STATE OF HAWAII
DEPARTMENT OF TRANSPORTATION
HIGHWAYS DIVISION

GRADING, DRAINAGE & CONSTRUCTION PLAN
FORT WEAVER ROAD
STA. 93+50.00 TO STA. 94+50.00
FORT WEAVER ROAD
SOUTH OF FARRINGTON HIGHWAY
TO THE VICINITY OF RENTON ROAD
SCALE: 1" = 50' DATE: SEPT 1979
SHEET NO. 1 OF 9 SHEETS

FORT WEAVER ROAD
SOUTH OF FARRINGTON HIGHWAY
TO THE VICINITY OF RENTON ROAD

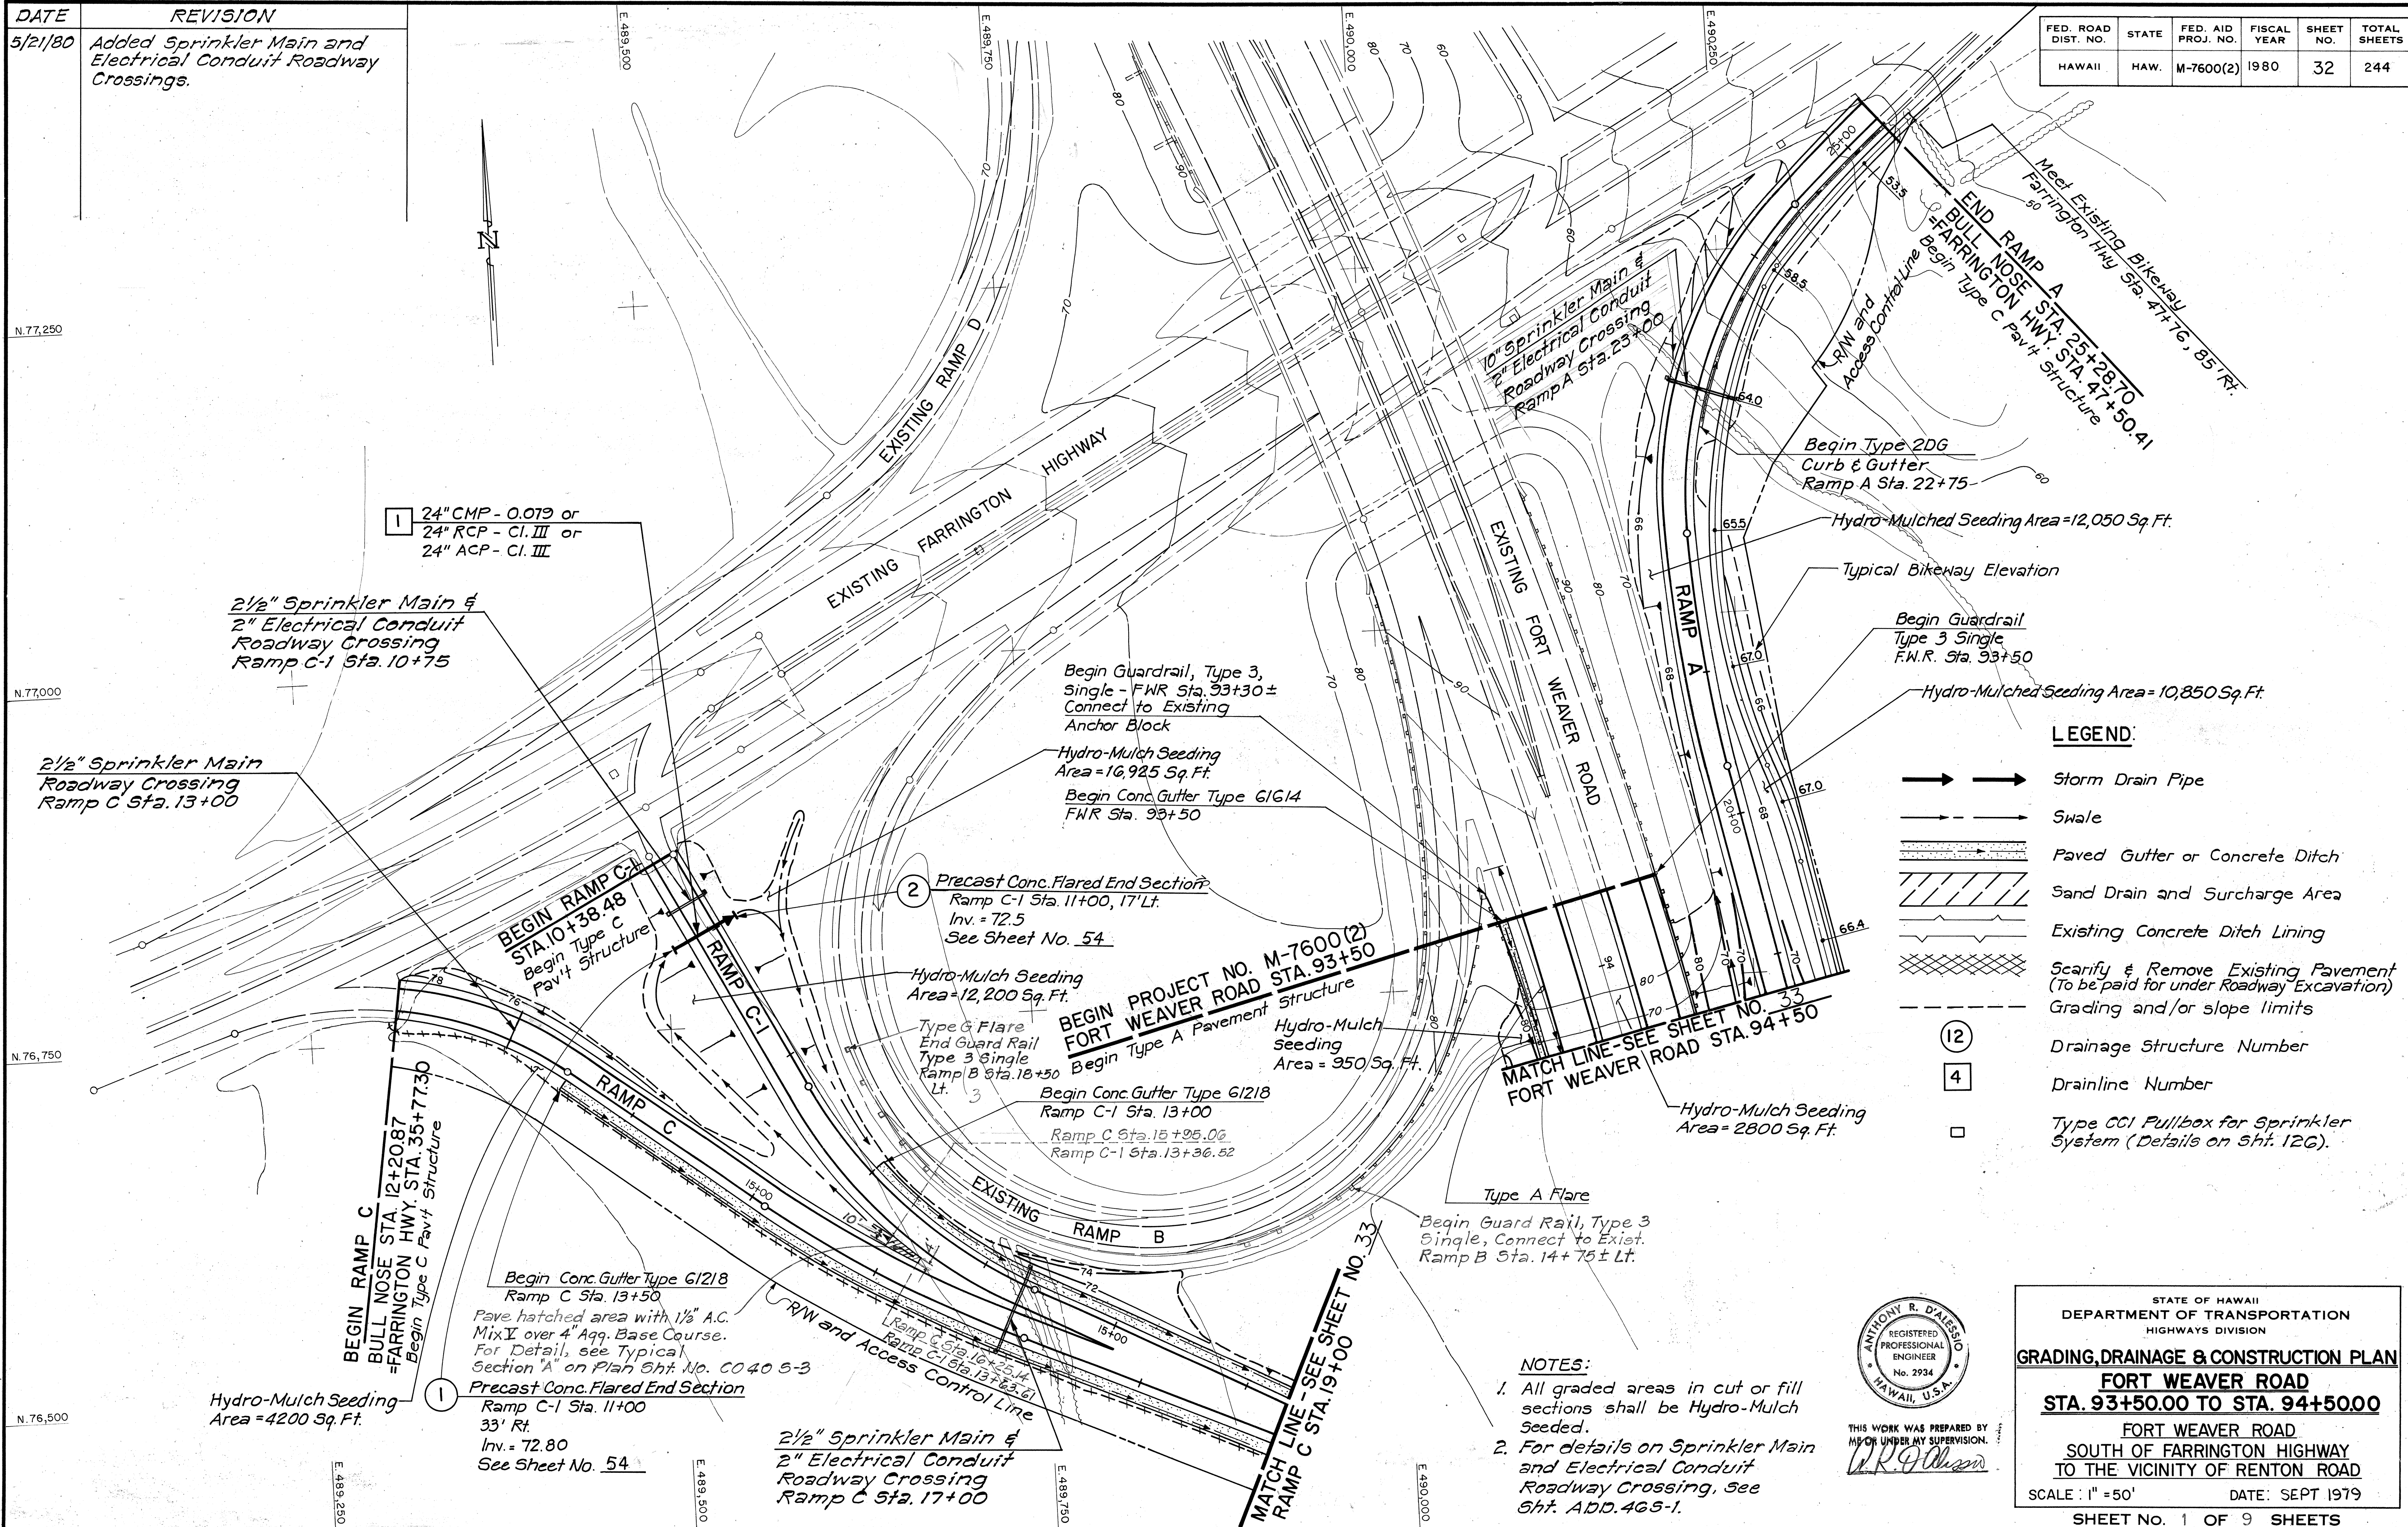
DATE	REVISION
5/21/80	Added Sprinkler Main and Electrical Conduit Roadway Crossings.

GRADING, DRAINAGE & CONSTRUCTION PLAN
FORT WEAVER ROAD
STA. 94+50.00 TO STA. 110+50.00

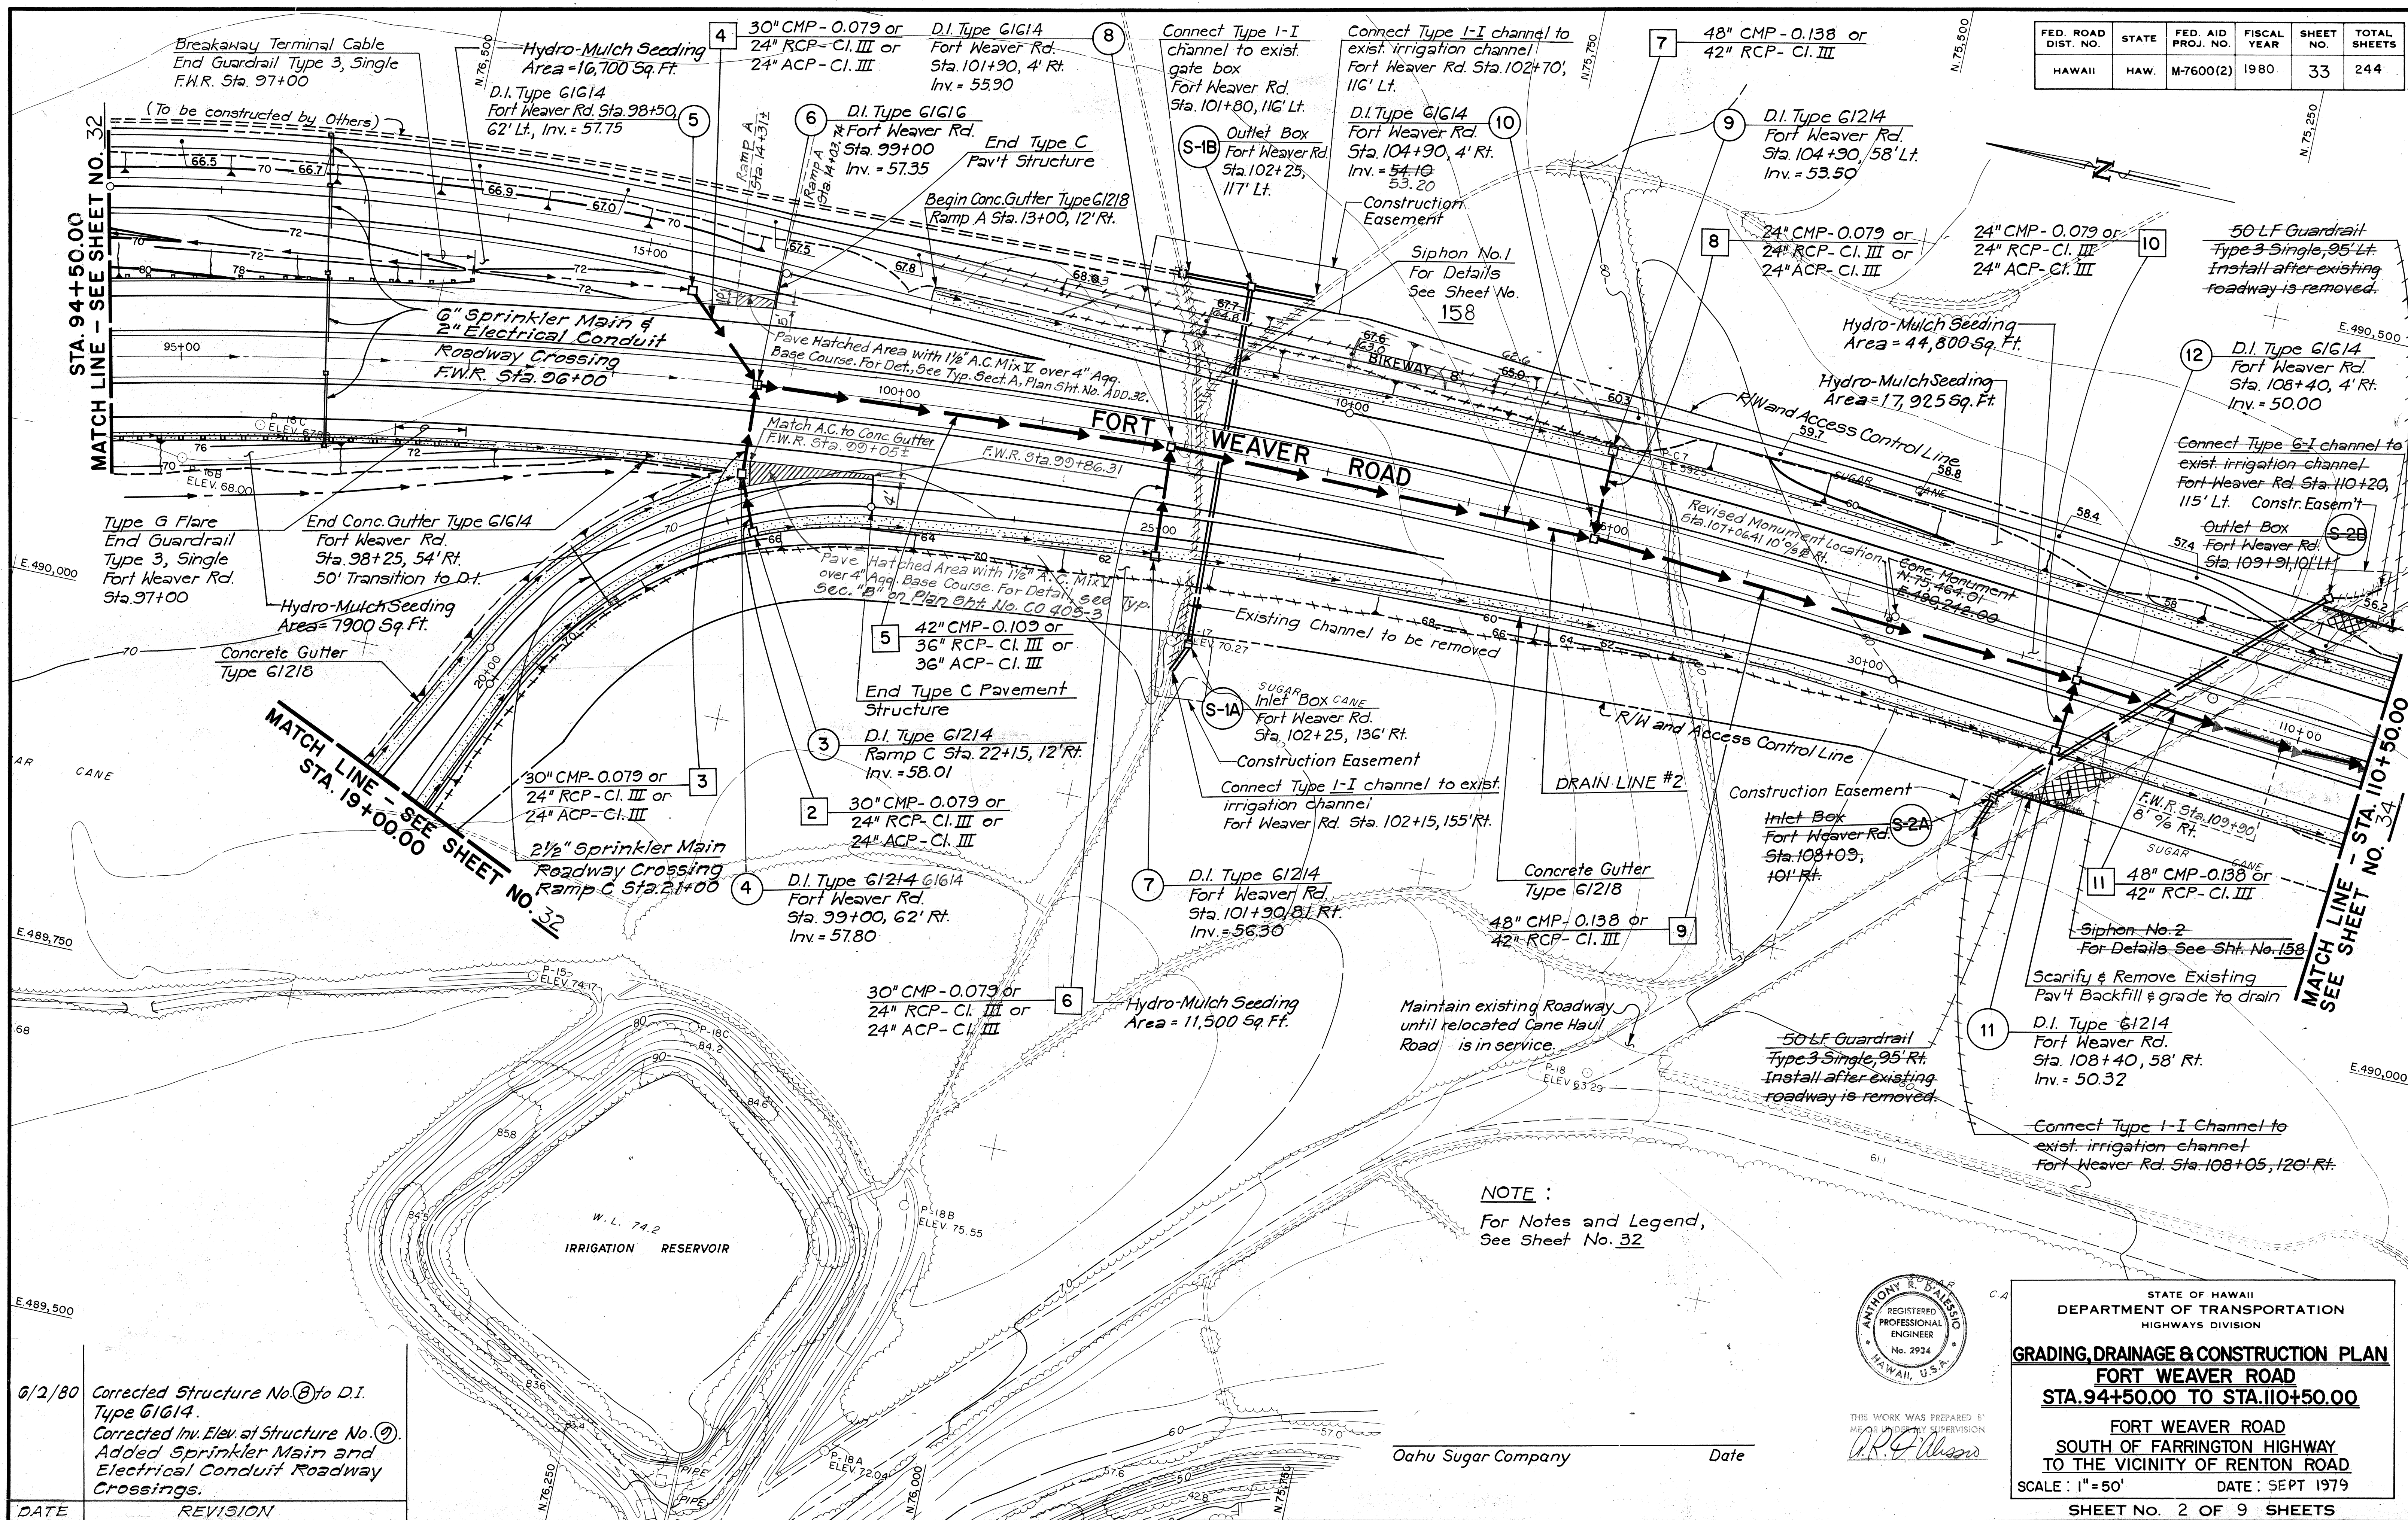
DATE	REVISION
6/2/80	Corrected Structure No. ② to D.I. Type G1614. Corrected Inv. Elev. of Structure No. ②. Added Sprinkler Main and Electrical Conduit Roadway Crossings.

STATE OF HAWAII
DEPARTMENT OF TRANSPORTATION
HIGHWAYS DIVISION
GRADING, DRAINAGE & CONSTRUCTION PLAN
FORT WEAVER ROAD
STA. 126+50.00 TO STA. 142+00.00
FORT WEAVER ROAD
SOUTH OF FARRINGTON HIGHWAY
TO THE VICINITY OF RENTON ROAD
SCALE: 1" = 50'
DATE: SEPT 1979
SHEET No. 4 OF 9 SHEETS

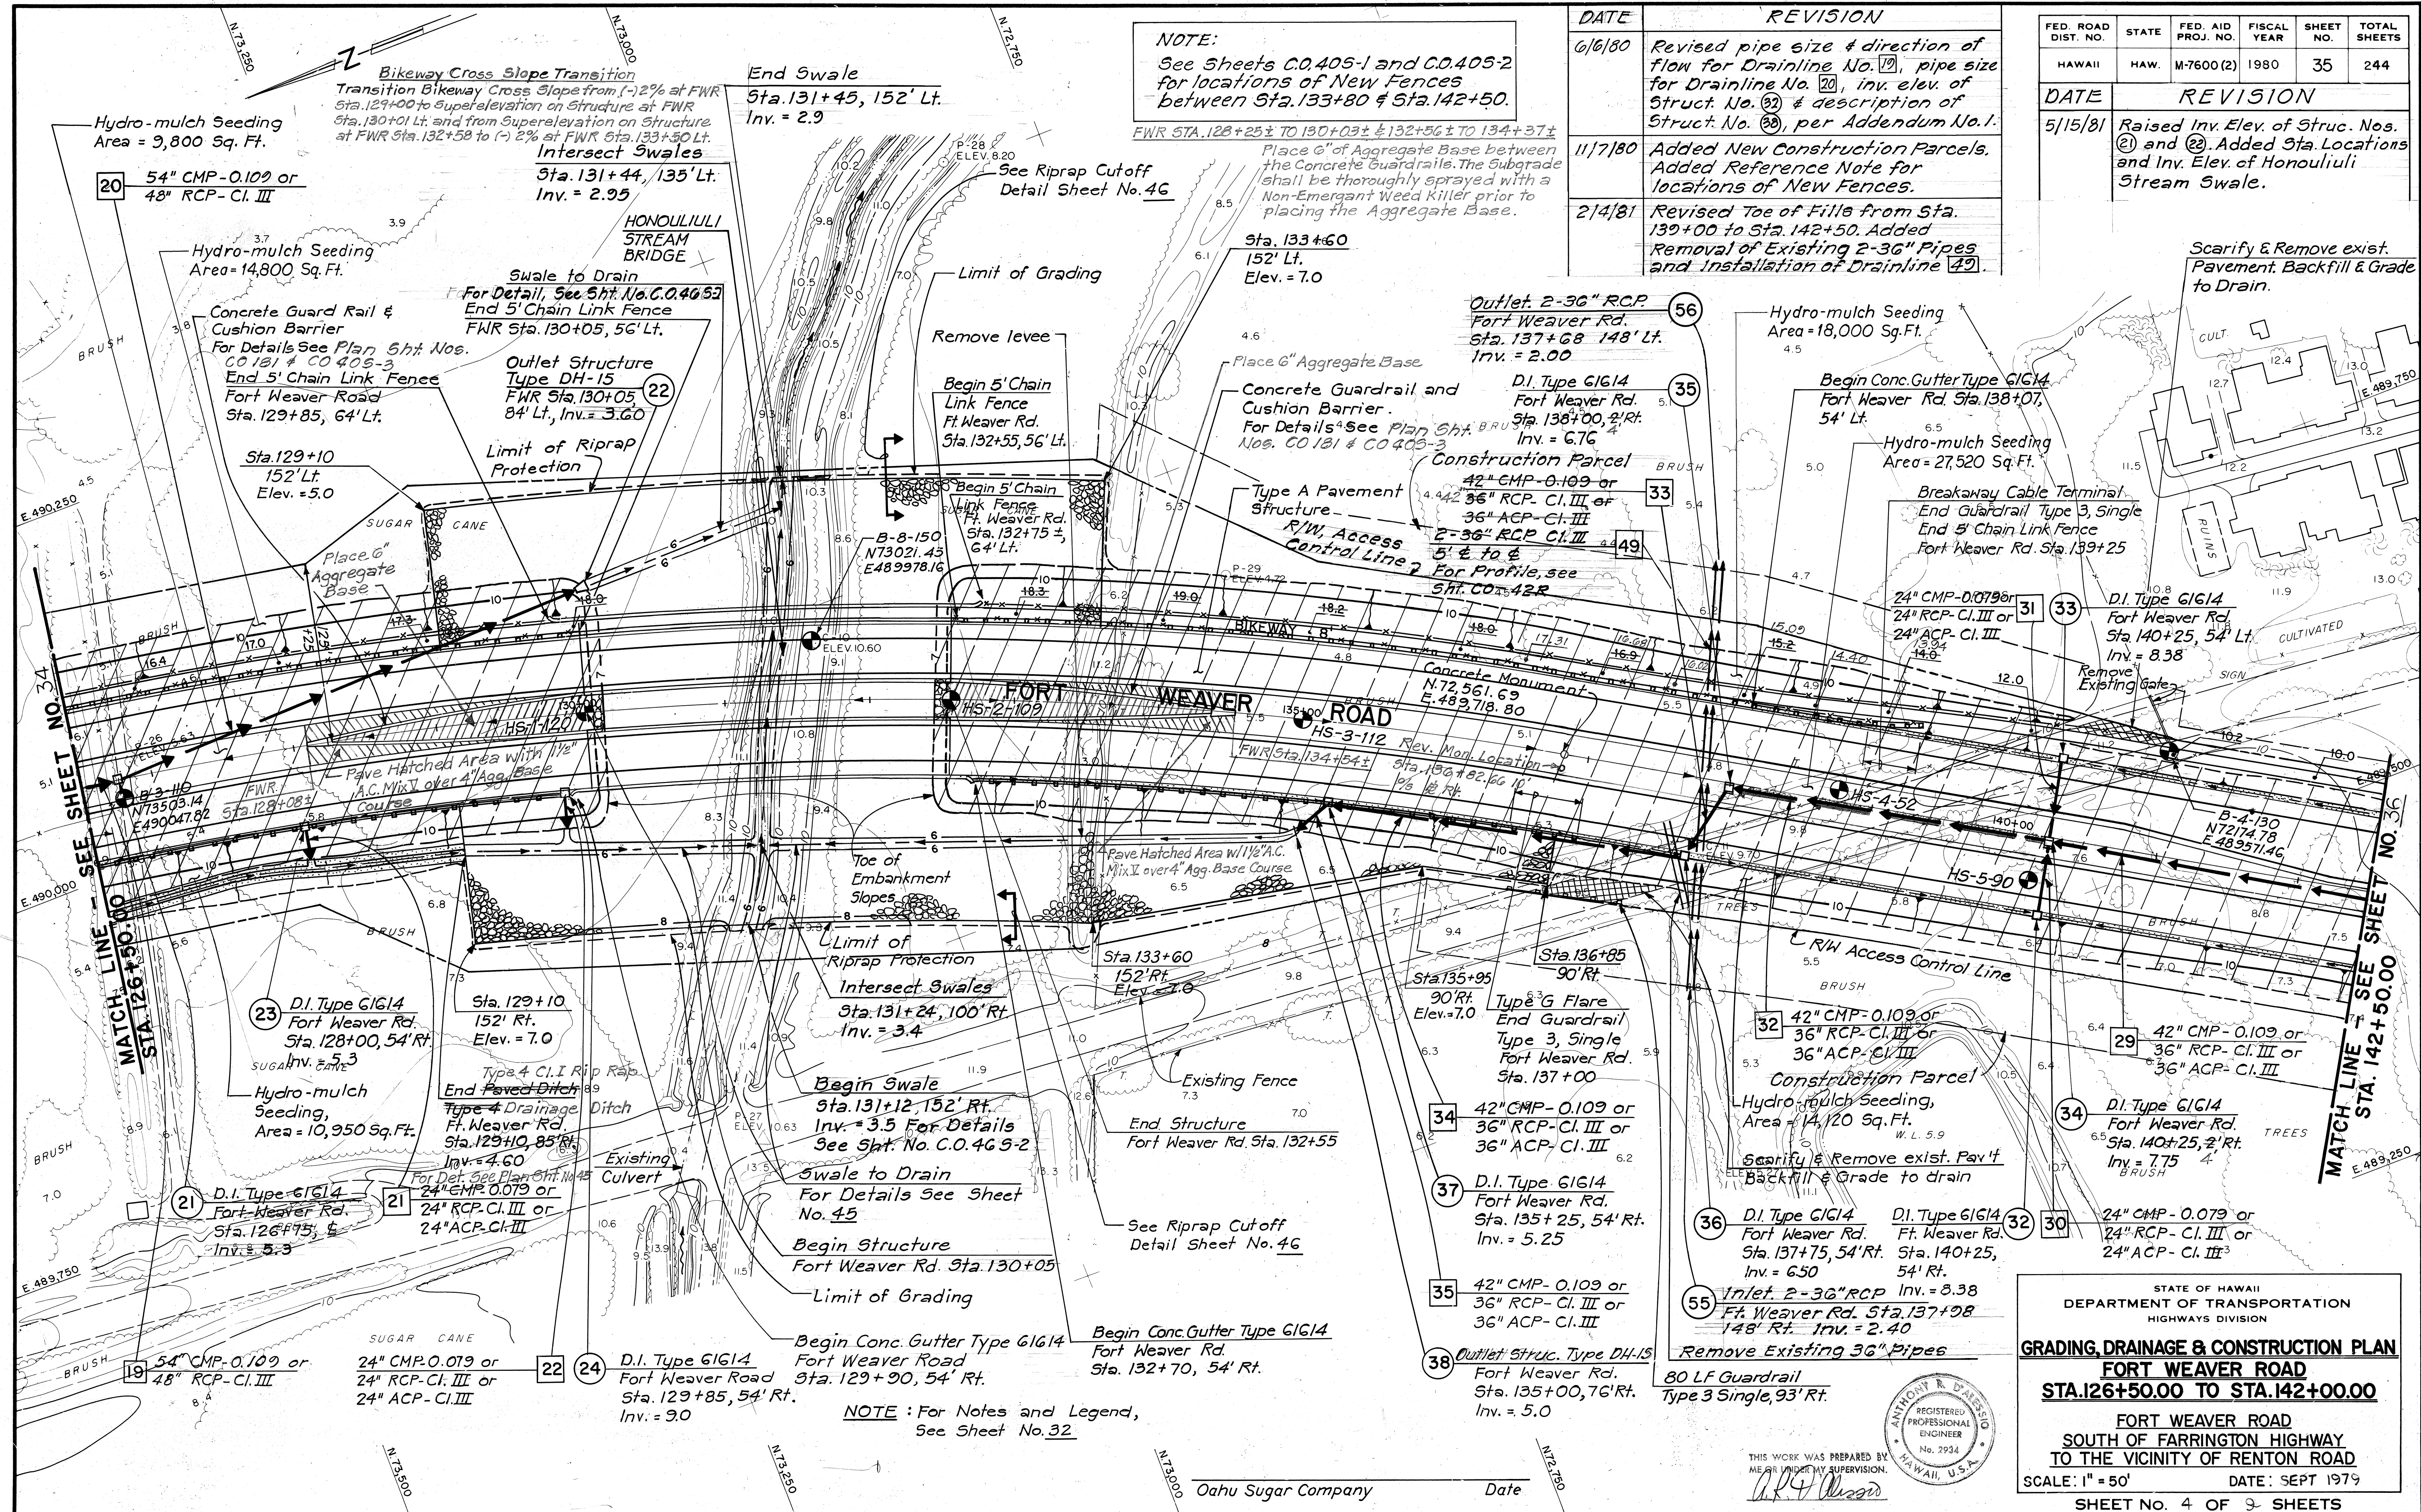
DATE	REVISION
6/6/80	Revised pipe size & direction of flow for Drainline No. 20, pipe size for Drainline No. 20, inv. elev. of Struct. No. 20 & description of Struct. No. 20, per Addendum No. 1.
11/7/80	Added New Construction Parcels. Added Reference Note for locations of New Fences.
2/4/81	Revised Toe of Fills from Sta. 139+00 to Sta. 142+50. Added Removal of Existing 2-36" Pipes and Installation of Drainline 49.

FED. ROAD DIST. NO.	STATE	FED. AID PROJ. NO.	FISCAL YEAR	SHEET NO.	TOTAL SHEETS
HAWAII	HAW.	M-7600(2)	1980	35	244
DATE	REVISION				
5/15/81	Raised Inv. Elev. of Struc. Nos. (21) and (22). Added Sta. Locations and Inv. Elev. of Honolulu Stream Swale.
